state college area CONNECTOR

South Alternative vs. US 322-5 PEL Corridor

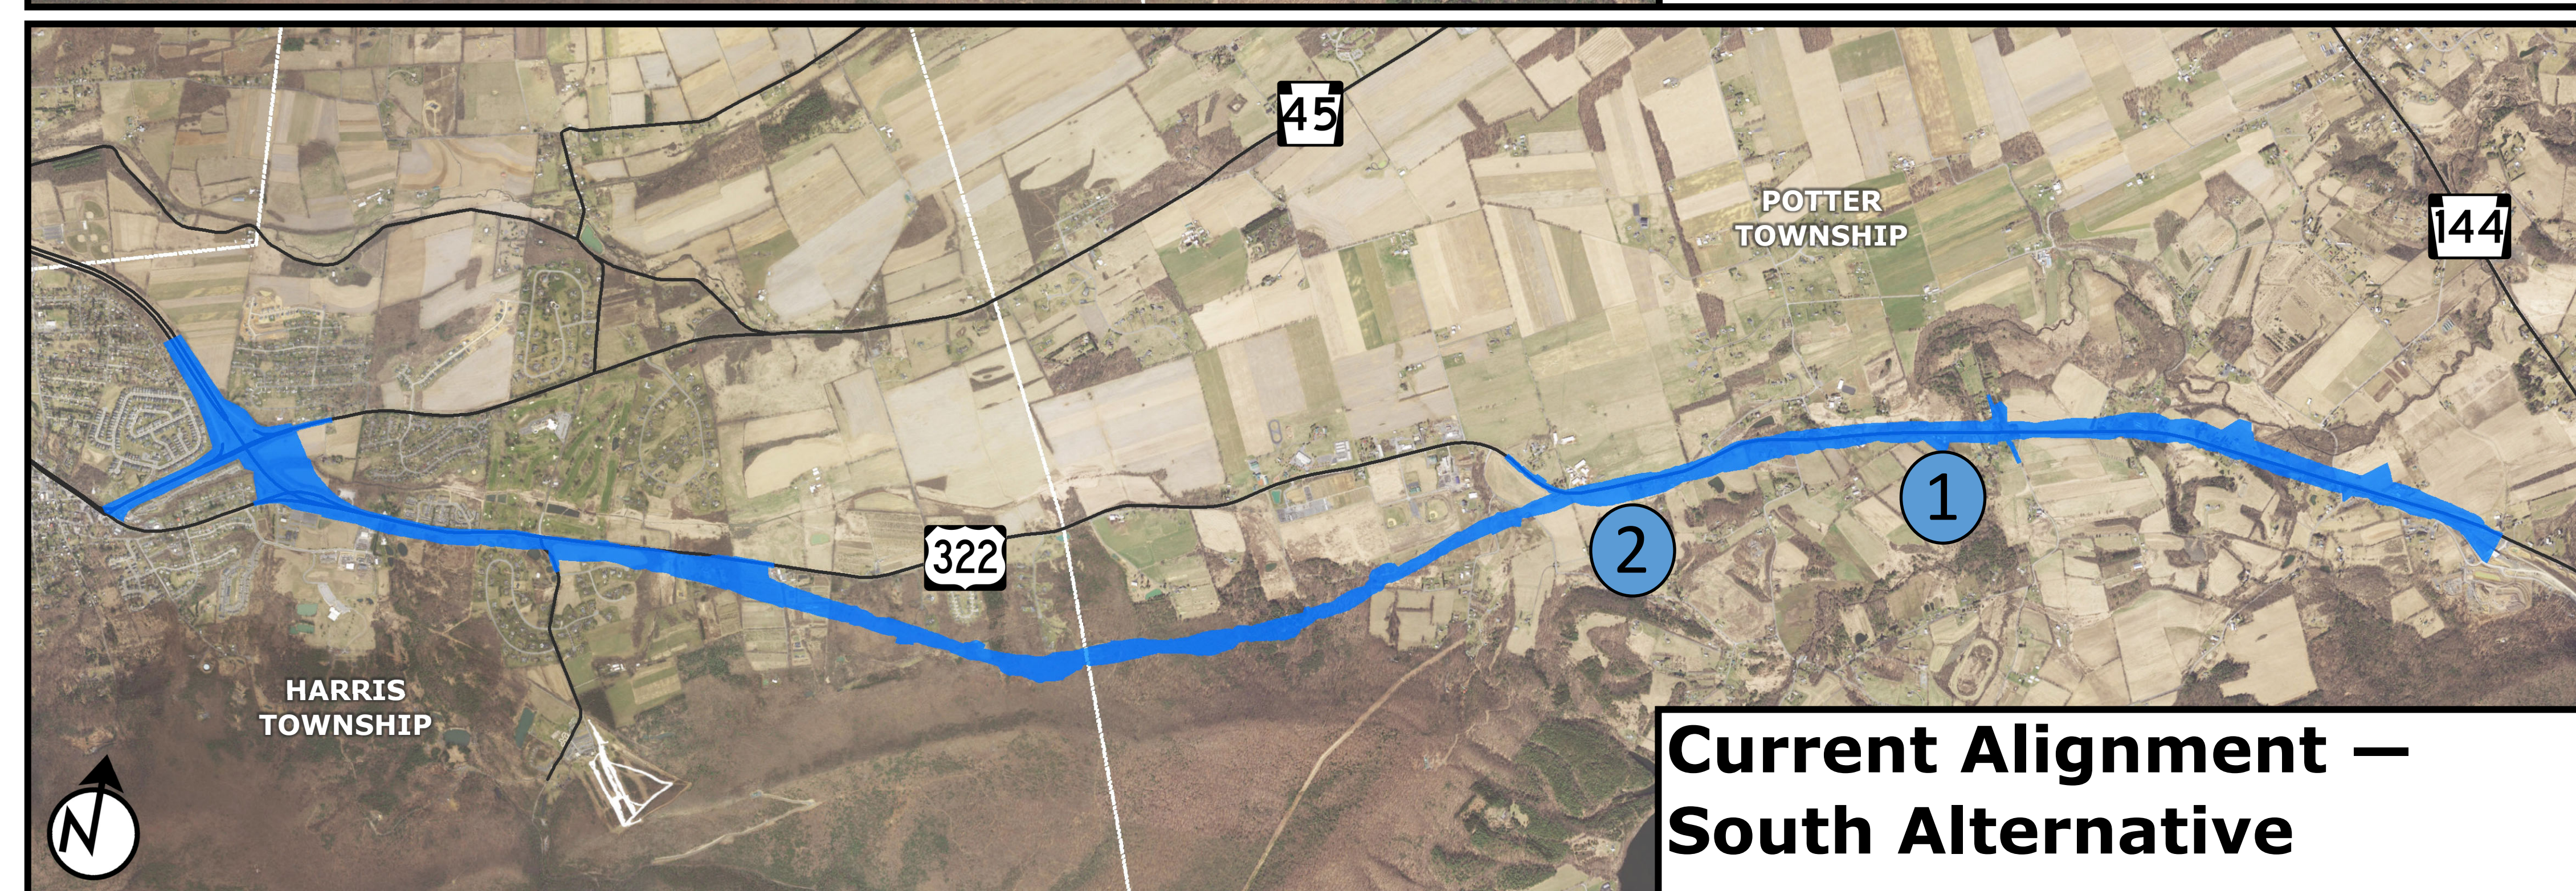
- ① PEL corridor was further south of US 322 in the east. The current alignment shifts north of existing US 322 to minimize effects to farm operations and other environmental features south of US 322.
- ② Removed the interchange.
